RE: *In the Matter Of: The Application Of Louisville Gas and Electric  
Company For Approval Of Its 2006 Compliance Plan For Recovery By  
Environmental Surcharge - Case No. 2006-00208*

RESPONSE OF  
LOUISVILLE GAS AND ELECTRIC COMPANY  
TO  
SECOND DATA REQUEST OF  
COMMISSION STAFF  
DATED AUGUST 21, 2006

**Response to Second Data Request of Commission Staff  
Dated August 21, 2006**

### Stack Plume Opacity Due to Sulfuric Acid Emissions

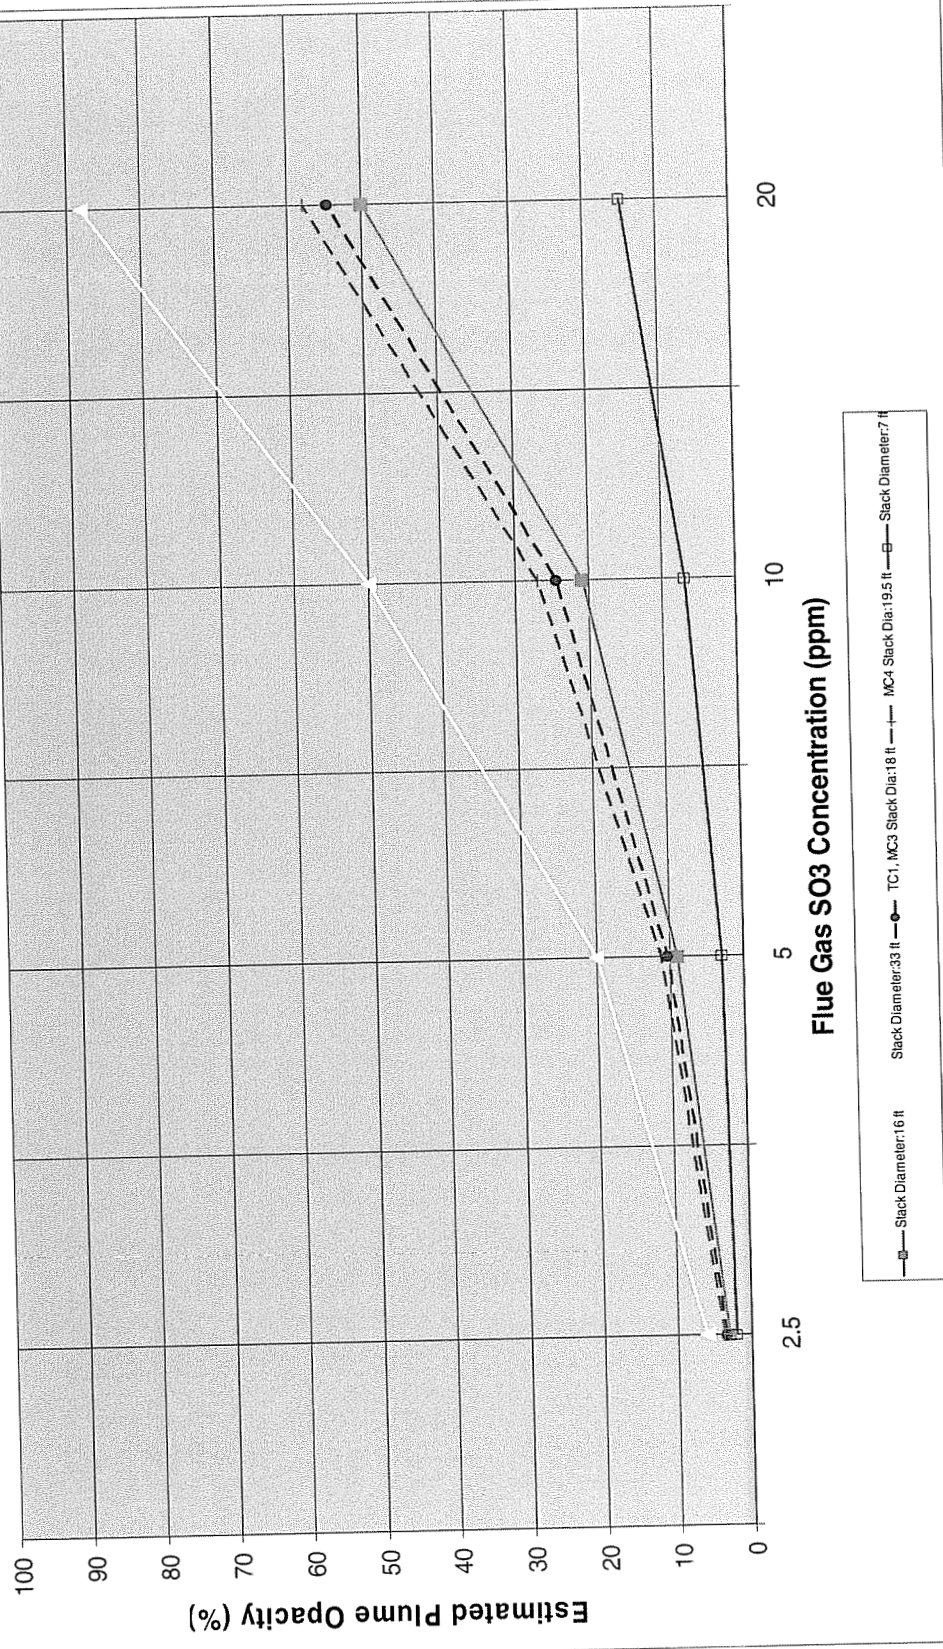
- b. Page 8 of 42 in Exhibit JPM-3 shows a chart relating flue gas SO<sub>3</sub> concentration with estimated plume opacity for different stack diameters.

What are the diameters of the stacks at Mill Creek Units 3 and 4 and Trimble County Unit 1?

[REDACTED] As included on Page 8 of 42 in Exhibit JPM-3, EPRI provides a chart relating flue gas SO<sub>3</sub> concentration with estimated plume opacity for different stack diameters (see response to item 3b below). By interpolation, the Mill Creek and Trimble stack diameter curves can be plotted on the graph (see Attachment). As indicated by this graph, a target of 5 ppm SO<sub>3</sub> concentration in the flue gas should allow the Company to maintain the plume opacity below 20% (the current regulatory limit on opacity for these units). Therefore, 5 ppm SO<sub>3</sub> concentration in the flue gas was selected as the screening level for SO<sub>3</sub> emission mitigation alternatives in order to control plume opacity and maintain compliance with current opacity regulations at the Trimble and Mill Creek Stations. However, final operational control parameters will be established through testing and calibration for each unit and application of USEPA Method 9 testing.

- b. The Mill Creek Unit 3 stack diameter is 18 feet.  
The Mill Creek Unit 4 stack diameter is 19.5 feet.  
The Trimble County Unit 1 stack diameter is 18 feet.
- c. The procedures for performing a USEPA Method 9 test (as found at [www.epa.gov/ttn/emc/promgate.html](http://www.epa.gov/ttn/emc/promgate.html)) are attached to this response. USEPA Method 9 is the compliance method for determination of visible emissions associated with a stack plume. Persons conducting Method 9 testing are required to attend training and maintain a certification of their ability to accurately perform the method. Method 9 is used by the USEPA to determine compliance with opacity emission standards.
